**Inspection End Date:** 08/14/2018 **Date Assigned:** 06/28/2018 **Inspection Start Date:** 08/06/2018 Firm Name & Address: Immunomedics, Inc., 300 The American Rd Morris Plains, NJ 07950-2460 US Firm Mailing Address: 300 American Rd, Morris Plains, NJ 07950-2460 United States FEI: 1000526871 County: MORRIS **Est Size:** 0 - 24,999 **JD/TA:** 35 **Phone:** (973)605-8200 District: CDER-DIA Profiled: Yes **Conveyance Type: Inspectional Responsibility:** Field % Interstate: **Endorsement** This pre-license inspection of Immunomedics Inc. (b) (4) intermediate manufacturing site was conducted from August 6 ? 14, 2018 following a request by the Division of Microbiology Assessment, Branch IV (DMA/OPF/OPQ//CDER) and Division of Inspectional Assessment, Branch 1 (DIA, OPF/OPQ). The inspection was conducted in support of (b) (4) The inspection covered (b) (4) intermediate manufacturing, testing laboratories, utilities, and warehouse. The inspection was system-based and covered Quality, Facility and Equipment, Production, Material, and Laboratory systems. A thirteen-item Form FDA 483 was issued to the firm at the close of the inspection on August 14, 2018 with the following observation: 1. T

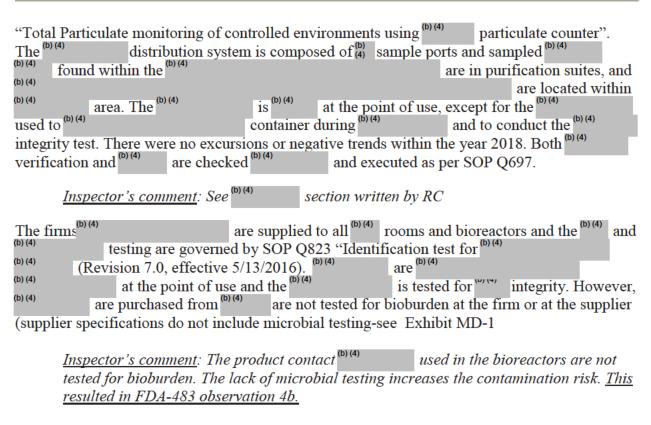
liquids in case of a catastrophic spill. All operations downstream the (b) (4) bioreactor are conducted using single-use bags, which may contain up to (b) (4) L liquid material. <u>Inspector Comment</u>: This was a FDA-483 observation (<u>Observation 7: The design of the</u> facility is inadequate in that no drains are present in the purification rooms.) HVAC and BMS (This section was written by RC) I reviewed the drawings of the facility. The facility was designed for research and development, with multiple small room. The manufacturing areas are Grade D (upstream processing) with Biological Safety Cabinets (BSC) monitored to Grade A for open processes, including master and (b) (4) cell bank thaw and (b) (4) and assembly of critical open operations conducted during manufacturing (for example. (b) (4) . Purification areas have Grade C and D classification. All have the same classification that the rooms that they feed. Upstream manufacturing areas in a different part of the building that purification areas; (b) (4) purification areas and areas are separated by a clean corridor. The facility is serviced by (b) air handling units in the (b) (4) area and (b) units in the purification areas. Air flow is segregated between cell culture, purification (b)(4) and (b) (4) The air handling unit that services the (b) (4) (b) (4) area (AHU7) is also used for a storage room in the (b) (4) area. However, the room has 100 % filtered air with no recirculation. The target number of air exchanges is (b) room changes/hour in Grade C areas and (b) room changes/hour in Grade D areas. The differential pressure in the facility has a (b) (4) design, with pressure increasing with the criticality of the process. Pressure monitoring of the facility has been conducted manually until a continuous pressure monitoring system was installed in July; the system is currently being qualified. I reviewed SOP-0239 "Monitoring differential pressure, temperature and humidity" v2.0 effective August 4, 2018. According to the SOP, temperature. Humidity and differential pressure in manufacturing areas are monitored (b) (4) during operations. However, when inspecting the pressure differential logs, it was noticed that pressure is monitored (b) (4) during operations. I reviewed the differential pressure data between room (b) (4)

<u>Inspector Comment</u>: This was an FDA-483 observation (<u>Observation 6.a: Air pressure in the GMP areas is not adequately maintained</u>.")

(Class D corridor) between July 24th and August 1st, 2018.
